Work Order ID 143687

Under Review Notification

Product #: D412-698-023

Product Name: AUTOMATIC DOOR OPENER KIT

D3594-043 FLOOR DOUBLER ASSEMBLY

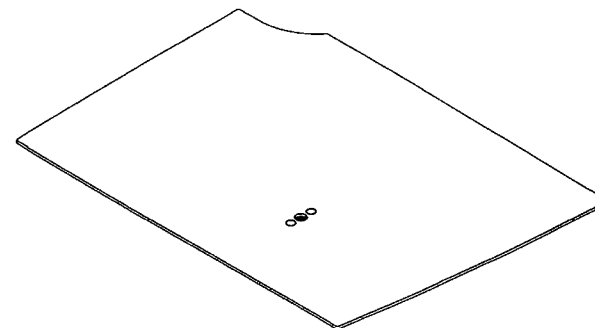
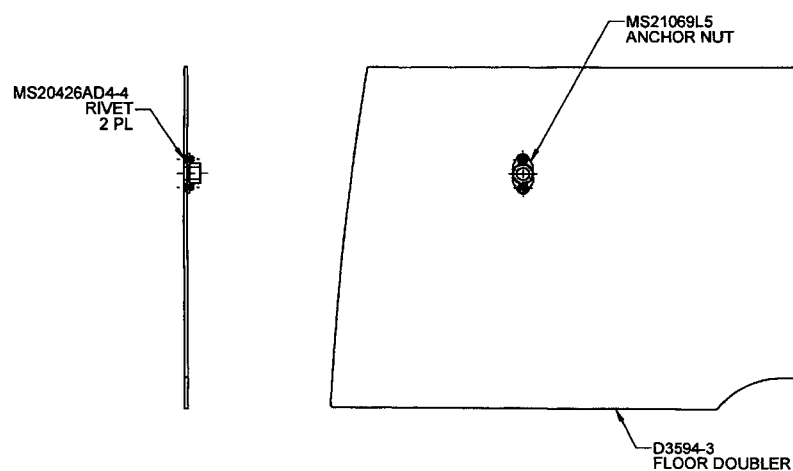
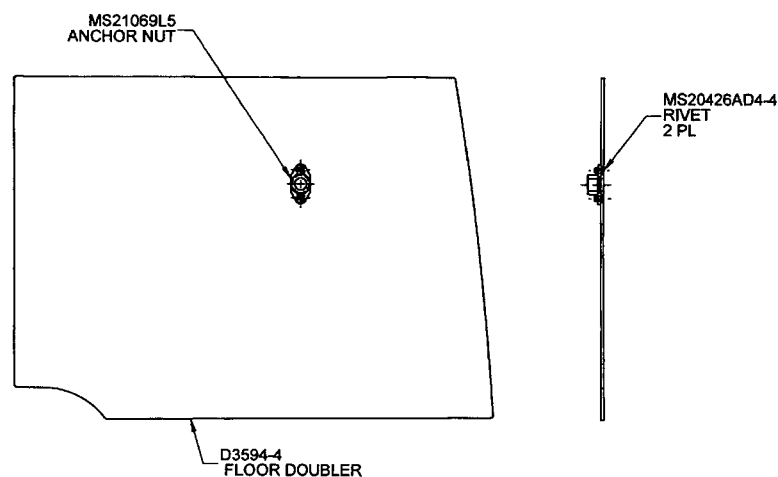
If shipping to Bell Helicopter Mirabel: must ship D412-698-023 with enlarged D3594-043/-044/-3/-4. Eng. To sign off deviations on W/Os.
Change: addition of material, 0.25", on the inboard and outboard edges as shown to facilitate installation with existing equipment.
